PJM SRTEP Meeting 2-13-2018

Questions Pertaining to Proposed Projects & Scopes

AEP Transmission Zone: Supplemental
Ambler Ridge Station

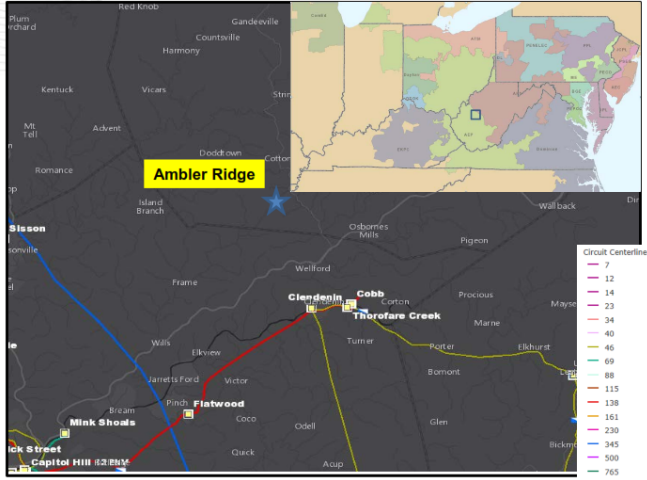
- **The problem statement states two 138kV CB's will be installed at Ambler Ridge, however the potential solution says two 138kV MOABs. Which statement is correct?**
- **Who will own these breakers or MOAB's, and circuit switcher?**
- **Is this project owned by TranSource?**
- **Why is there no transmission cost associated with this project? AEP has presented multiple projects where AEP has included 138kV circuit breakers at distribution stations as transmission cost. Why is the same**

methodology not being applied here? Is this AEP's standard practice?

- **Why does the map for this project not show the Transource proposed project?**
- **Transource originally proposed a ~17 mile 138kV line extending from the Thorofare area and tying into the FE system via the Chloe station.**
 - a. **Did this project's scope change to accommodate this proposal? If so, has Transource presented their scope change and the cost associated with this change?**
 - b. **Whose customers will be incurring the cost of this reroute, FE's, APCO's, AEP Transmission?**
- **How can AEP establish a 138kV station and CB's with no transmission cost and why isn't AEP applying this same methodology to all of its transmission projects?**

AEP Transmission Zone: Supplemental
Newcomerstown Line Conversion and Transformer

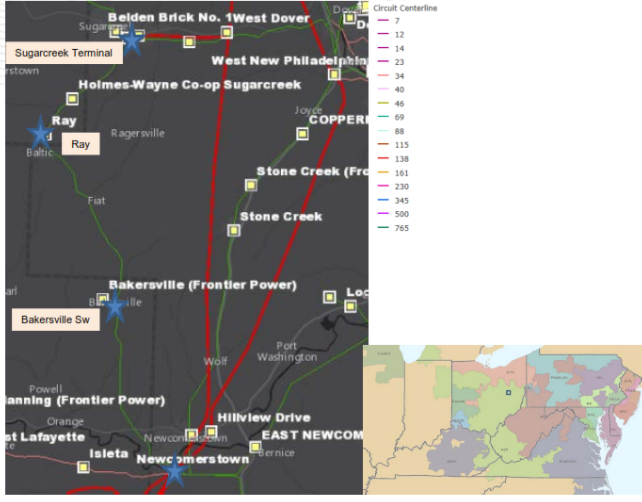
- Was AEP's FERC Form 715 data used in this analysis or was some other data used?
- Did AEP use the PJM 50/50 load forecast to determine this overload? What was the limiting element being overloaded? Was it the transformer?
- Was a load profile other than the profile in PJM's 2017 RTEP case used?
- What case was used for this study?
- Were there any new loads in the case used for the study that were not in the 2017 PJM RTEP case? If so, what were the changes in load levels and at what stations were these changes applied?
- Please provide the number of through faults recorded on the transformer.

- **Would the N-1-1 outage of the Newcomerstown – Bakersville and the Sugar Creek Terminal – Sugar Creek also result in an outage to all customers served from the Newcomerstown – Sugar Creek Terminal?**

AEP Transmission Zone: Supplemental
Harpster – Waldo 69 kV Rehab

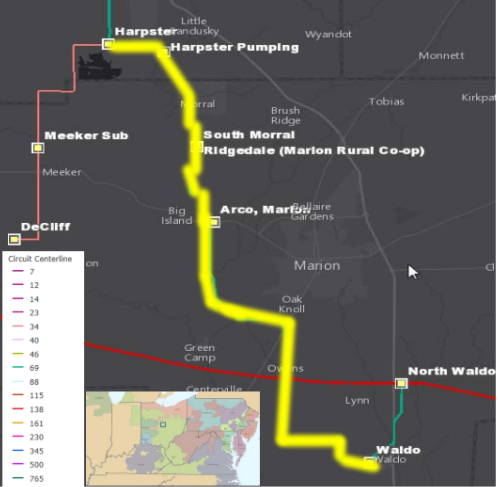
- **Will wood or steel being used for the rebuild?**
- **Why is such a large conductor required? Why would 336 ACSR, or 556 ACSR not be adequate?**
- **Will this line be designed to accommodate future conversion to 138kV**
- **Are wood structures adequate for this line?**
 - **Please provide AEP's cost determination for the wood construction design, if steel structures are being proposed.**

AEP: Cabin Creek – Clendenin Rebuild

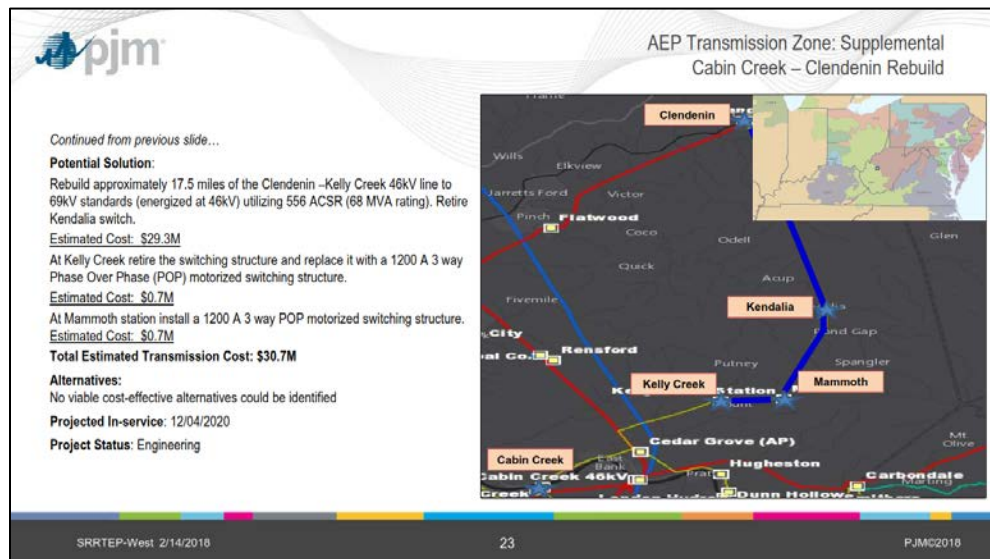
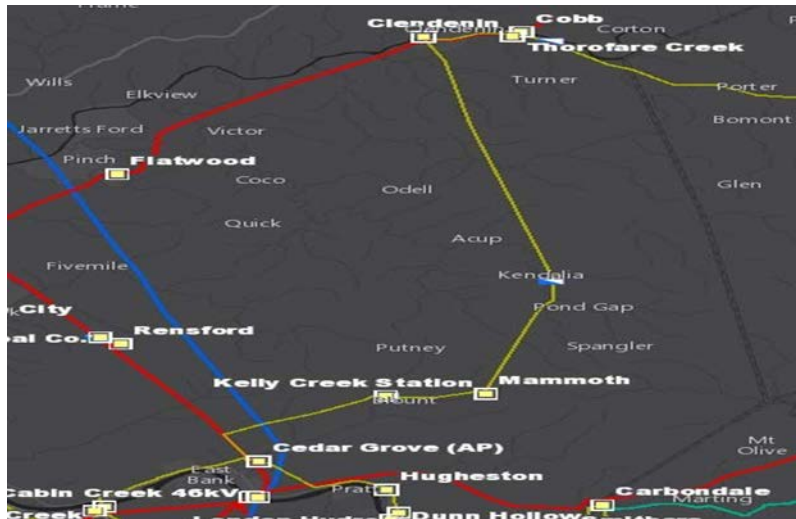
- **Per AEP one line diagrams, Kendalia is bolted close. Is there load served from this station or has the station been retired?**
- **Per AEP one lines the proposed rebuild is ~17.5 miles**
 - a. **All should note, a radial 138kV line will not be the only source serving the Clendenin station in the future. Transource is building a project that ties this radial line to APS system located east of the Clendenin station. This project is also associated with the Ambler ridge project previously presented**

- **Why has AEP chosen not to present any alternatives?
Were alternatives investigated, if so what where they?**

Alternatives to Consider:

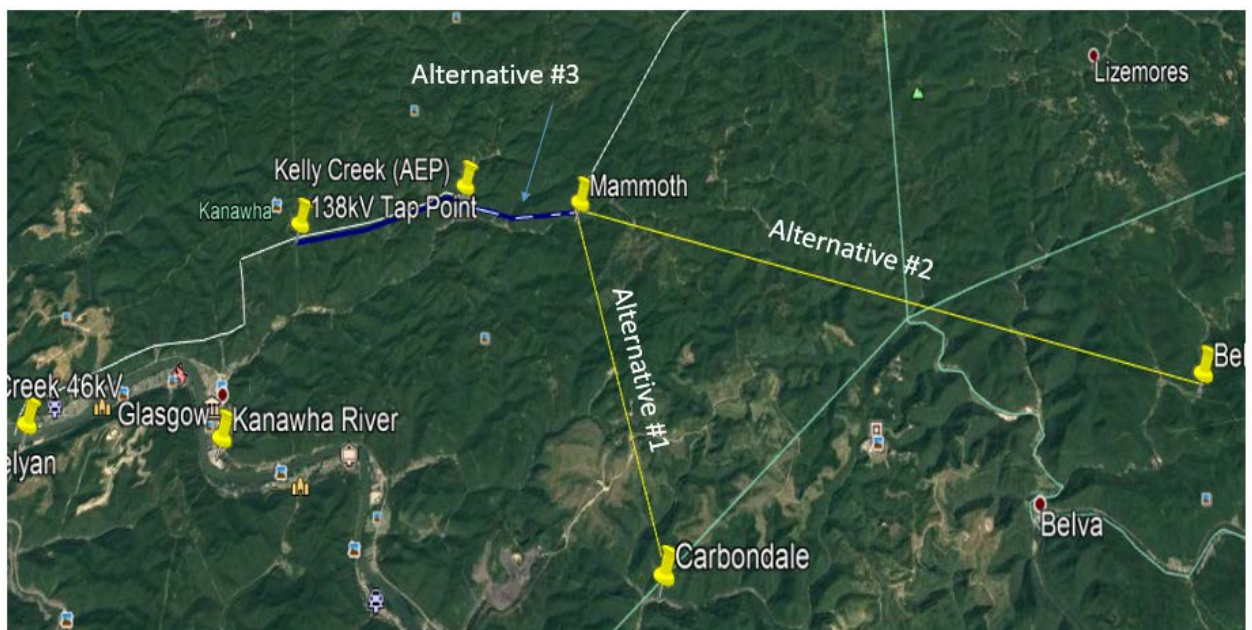
- **Alternative #1: Has AEP considered Carbondale – Mammoth by extending the 46kV circuit southeast towards Carbondale:**
 - a. **Distance: ~5.3 - 6.7 Miles**
 - b. **Possible reduction in line length: ~9-10miles**
- **Alternative #2: Has AEP considered Belva – Mammoth by extending the line east towards Belva station:**
 - a. **~10.3 – 13.08 Miles**
 - b. **Possible reduction in line length: ~3-6 miles**
 - c. **Design line for 138kV for possible future conversion.
Proposal would provide redundant, future 138kV**

path between Kanawha Area and the Belva Area when conversion is needed.

- **Alternative #3: Has AEP considered building a double circuit extension to Kelly Creek and Mammoth?**
 - Addresses a much larger range of conditions issues.**
 - Also eliminates future needs to address Kelly Creek – Cabin Creek 46kV path which connects into Cabin Creek.**

- Tap the 6-wired Kanawha River – Chloe circuit, looping in and out of both Kelly Creek and Mammoth stations via a double circuit line**
- Convert Kelly Creek & Mammoth to 138kV stations?**

- **What is being done about the condition of the Mammoth Substation? Would this not be included into AEP's "Holistic Solution"? Same question for Kelly Creek station? Are these distribution stations? Is that the reason there condition issues are not being address?**

AEP Transmission Zone: Supplemental Dorton Station Rehab

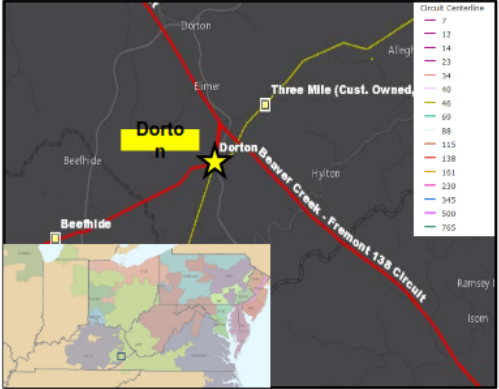
- Please provide the current rating of the transformer being replaced.
- Please provide the number of through fault events
- Please provide the CO/CO2 ratio value for this unit.
- Please provide an explanation about why this replacement was not complete as part of the Dorton circuit breaker installation project recently completed.
- Please provide projected dates for local area 69kV conversion and please provide the scope associated with this conversion.
- Describe, in detail, the three overlapping zones of protection noted above.
